ISLAND AVENUE, PEAKS ISLAND

Building permit for construction of one story <sup>frame</sup> addition 25' x 25' on the rear of Mr. Brown's store on Island Avenue, Peaks Island, is issued to the contractor, herewith, subject to the following. If for any reason you are unable or unwilling to abide by these conditions, it is important that you refrain from starting the work and return the permit card immediately so that adjustments can be made to show compliance with the Building Code. Numbered paragraphs below are similar to those and have about the same subject matter as in my letter of May 17. Where a number of paragraphs have been omitted in consecutive order, the questions raised in that paragraph have been cared for. Some of the notations below duplicate information in Mr. Hoar's letter of May 22, but are repeated here for the benefit of our inspector on the job and to avoid misunderstanding between him and owner or contractor as the work progresses. Permit is issued based on revised plans (two blueprints) received here May 22, 1950 and upon Mr. Hoar's letter of May 22, 1950.

I had hoped to be able to issue the building permit for construction of the addition on the rear of the

Roof Frame  
Scale  $\frac{1}{4}'' = 1'$   
R.S. Hoar

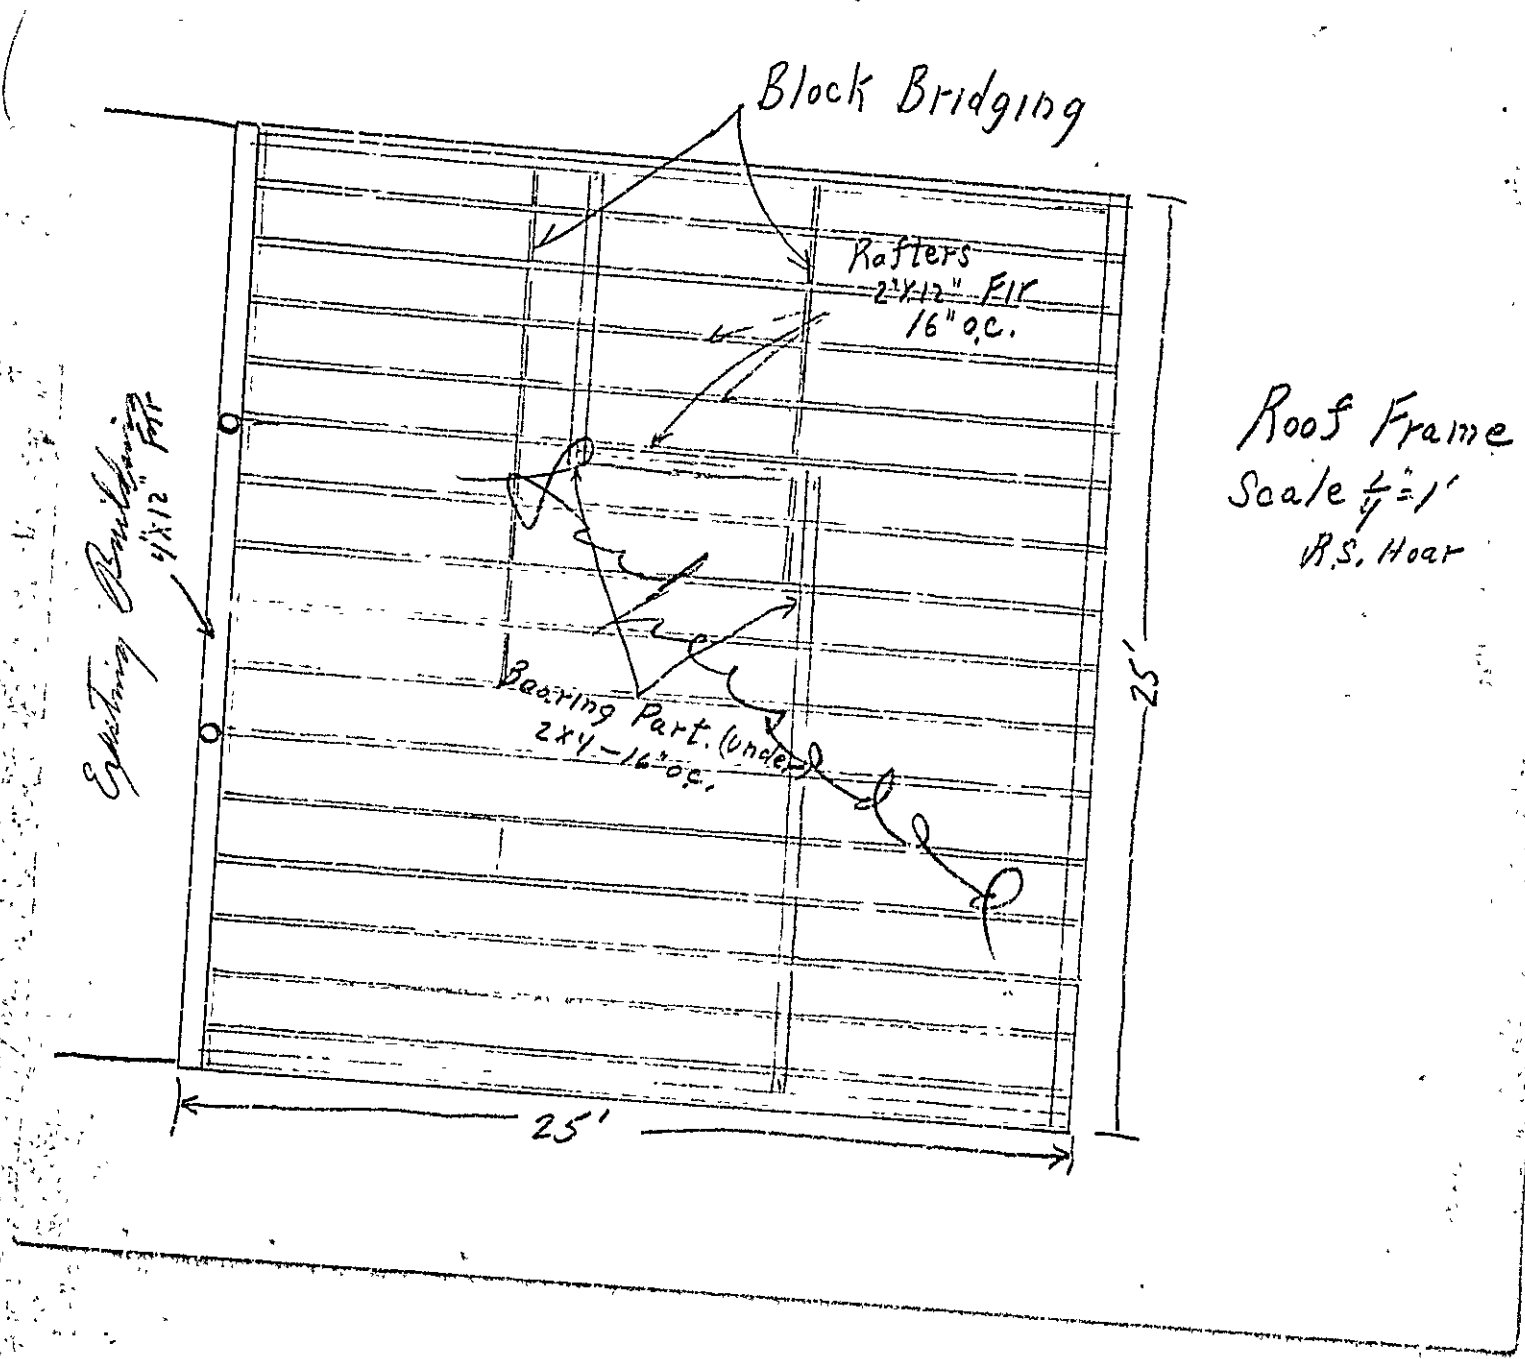
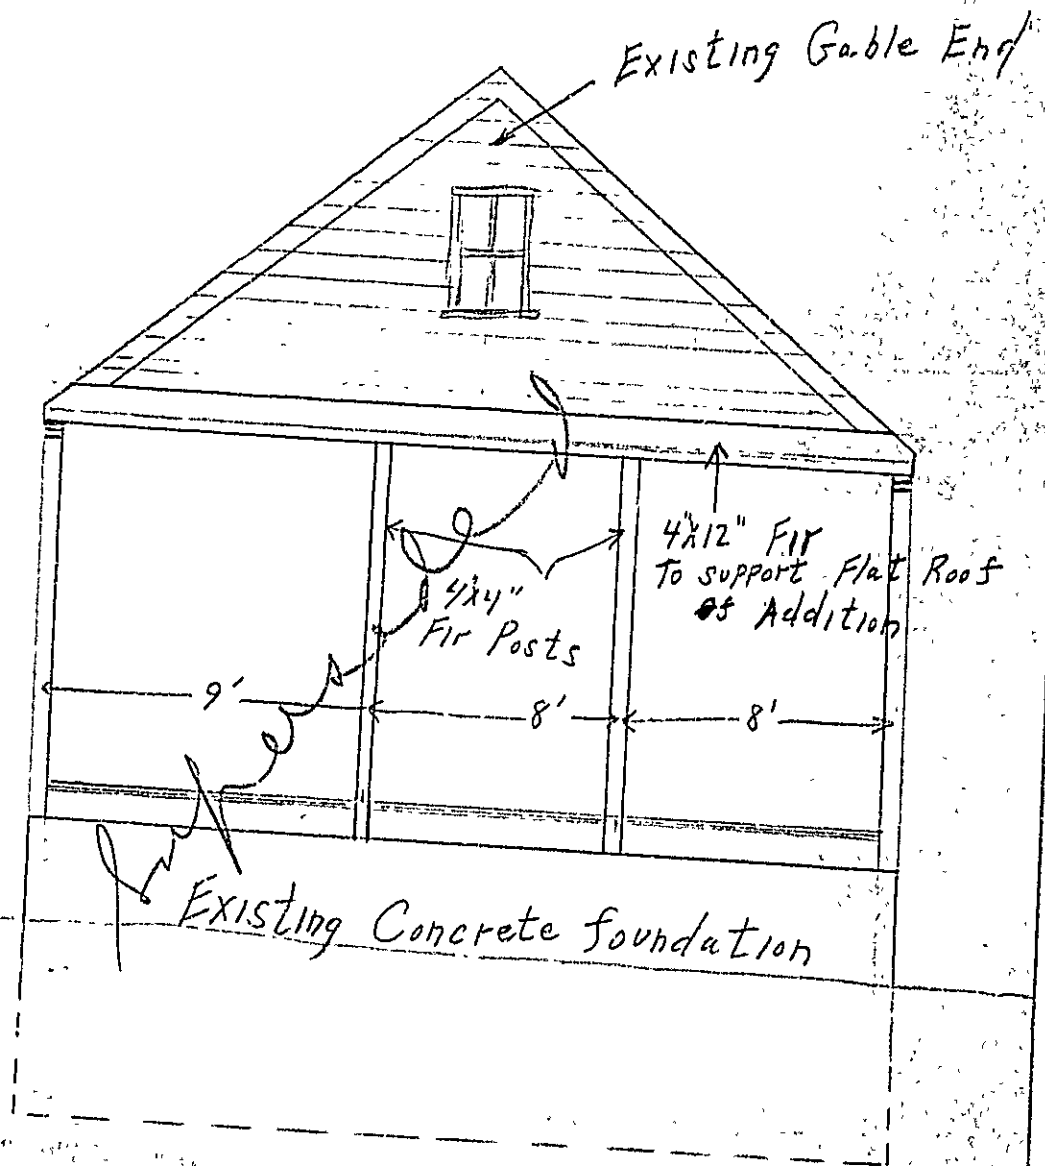
4. Apparently you plan to support the 2x12 roof joists upon the partitions between store room and refrigerator and the customer space, making them bearing partitions; but you have shown only doubled 2x8 under these bearing partitions an arrangement which is not nearly strong enough. Even if beams heavy enough to support this roof load down through the bearing partitions in first story were used, such heavy beams would almost certainly overload the center girder and probably the sill under outside walls, since the timbers supporting the partitions would get their bearing between piers. If you are to use these bearing partitions to provide support for the roof joists, it seems likely that the depths of the roof joists might be reduced somewhat if genuine Douglas Fir is to be used. The 4x12 Douglas Fir across the building under the roof joists also probably has considerable unnecessary strength in it. Apparently this 4x12 is to pick up the present rear gable end and one end of the new roof joists, the latter to be supported upon the 4x12 by nailing strips spiked to the sides. These roof joists develop a very substantial load and if nailing strips are to be used instead of supporting the roof joists on the top of the 4x12, I suggest that the nailing strips be no less than 2x4 and be lag bolted at frequent intervals to the beam instead of just spiking.

Bearing Part. (under)  
2x4-16" o.c.

Change in Rafters  
As Suggested by Building Dept.

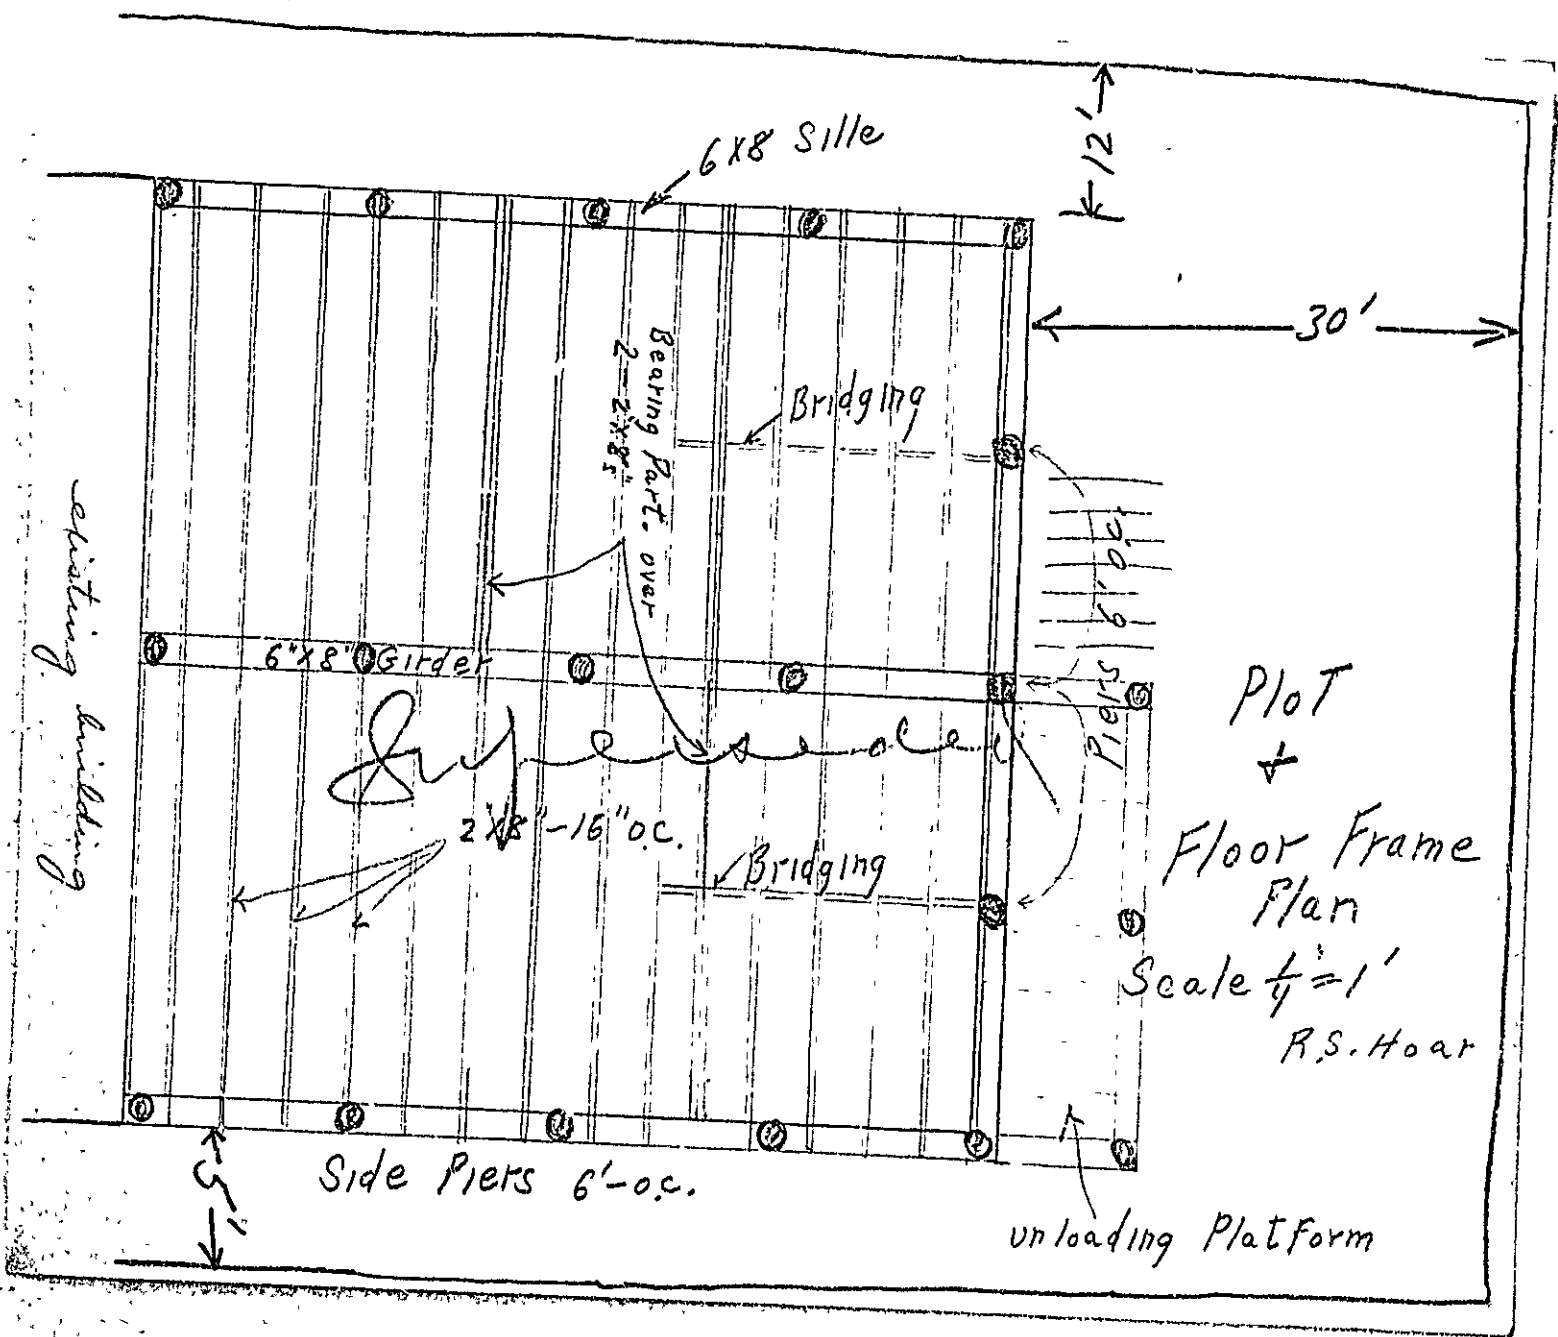
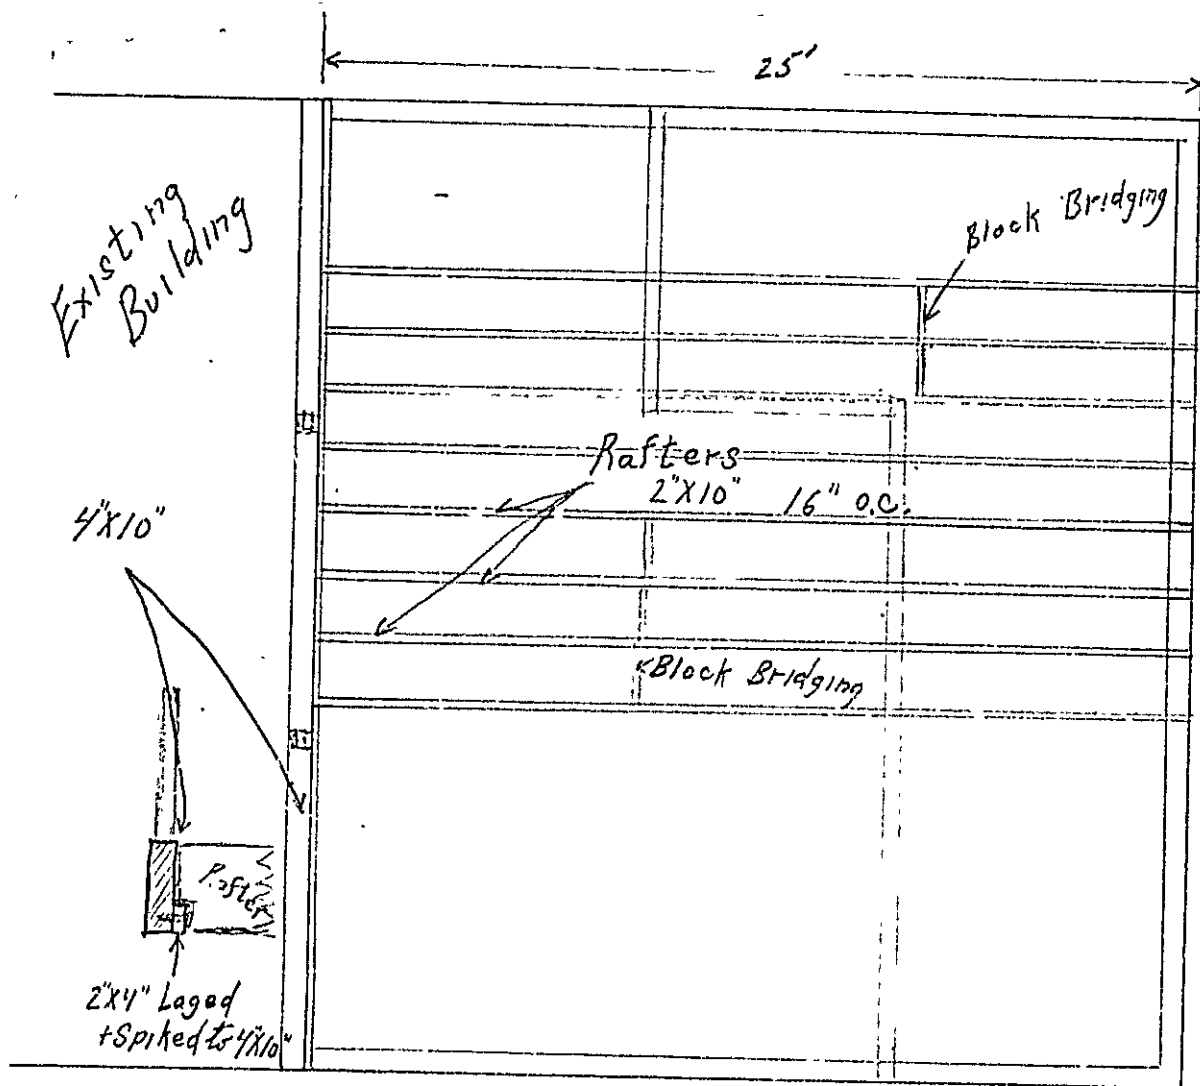
4. The 2x12 joists shown for the roof on spans of 25' are not sufficient, even though genuine Douglas Fir, if 24" from center to center as shown on the revised plan. Douglas Fir must be used in any event, not western hemlock or native spruce or hemlock. If the joists are full sized, 2" x 12", they should be spaced no more than 16" from center to center. If dressed stock thus reducing the size below 2x12, a spacing not greater than 14" from center to center is necessary. While it is of no concern under the Building Code, I recommend to you that you look into the proposition of running the roof joists the other way, making the cross partitions bearing partitions, designing adequate supports under first floor to support these bearing partitions and space the foundation piers accordingly so as not to overload the center girder or the sills. If this method is followed you would probably only need footings for the piers under center girder and perhaps under the rear wall, although you might need one or two more piers than shown on the plan. It is also possible that you could reduce the size of the roof joists, and it seems likely that the cost would be reduced because you must be paying a premium to get 2x12's 25' long. If you should decide to change the design in this manner, it will be necessary to file application for amendment to the permit now issued with the revised plan.

2. It is understood that the roof joists, the heavy beam running across the building where the addition will join the existing building and the posts under this beam will be genuine Douglas Fir, but all of the other framing members are proposed to be spruce. On this basis the 2x6 floor joists will not figure out strong enough on the 12' span, if spaced 16" from center to center. Either increasing the depth of the floor joists or spacing them 14" from center to center would meet the requirements.

Scale  $\frac{1}{4}'' = 1'$   
R.S. Hoar

5/8" ROD THROUGH 2x8 BLOCK AND  
BETWEEN 2x6 COLLOR BEAMS  
BOLTED TO RAFTERS DOWN  
THROUGH 2x6 BASE BEAM  
WHICH IS BOLTED TO EACH  
FLOOR TMBER

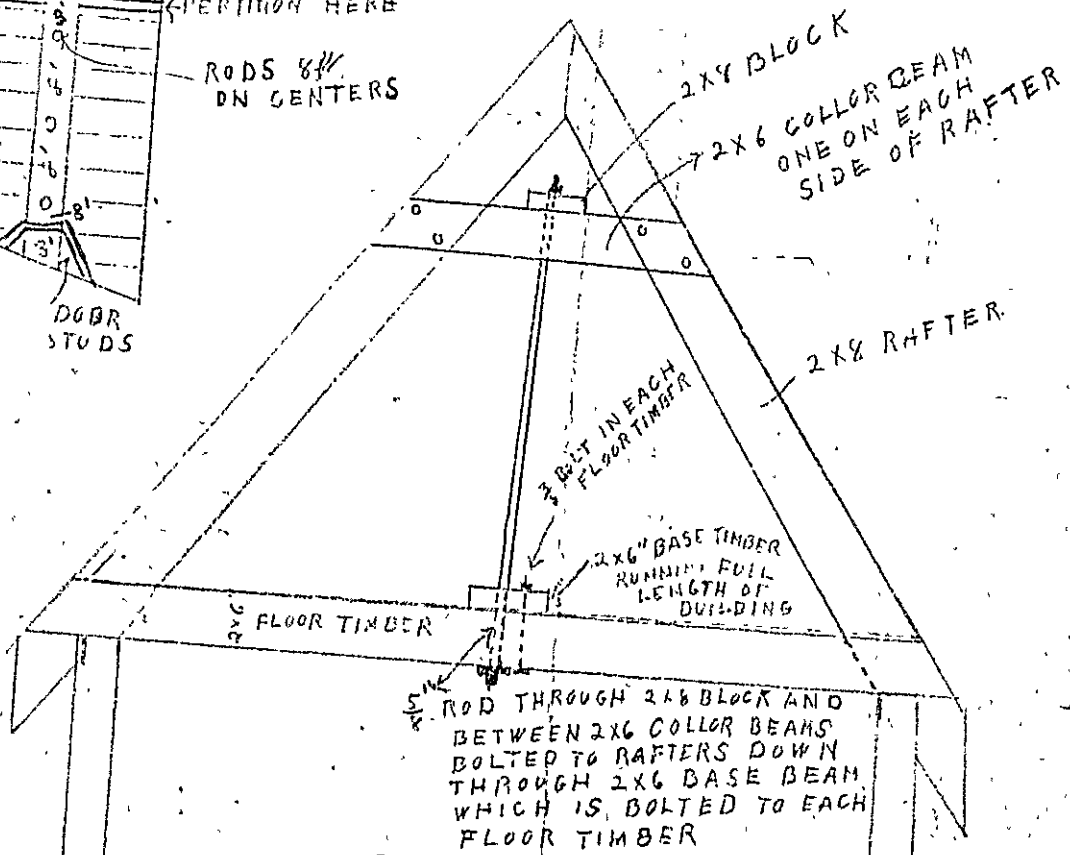
With reference to your store under construction on Island Avenue, Peaks Island and to my letter of August 10, 1936 concerning changes in the roof and ceiling construction over the store, after my inspector has reported fully the amount of the change in the construction, I have concluded that we will waive the point of filing an amendment to cover the change, since you are providing no stairway to the attic.

Please discontinue all work on this roof and ceiling construction until you have filed an application for an amendment to your original permit, and with the application a detailed plan showing just how you propose to accomplish the supports of the ceiling or floor in the attic. At the same time please indicate how you propose to reach this attic and what you propose to store up there, if anything, giving the sizes and spacing of the ceiling or floor joists and the spans as well as all other members which contribute to the support of the roof and floor structure.
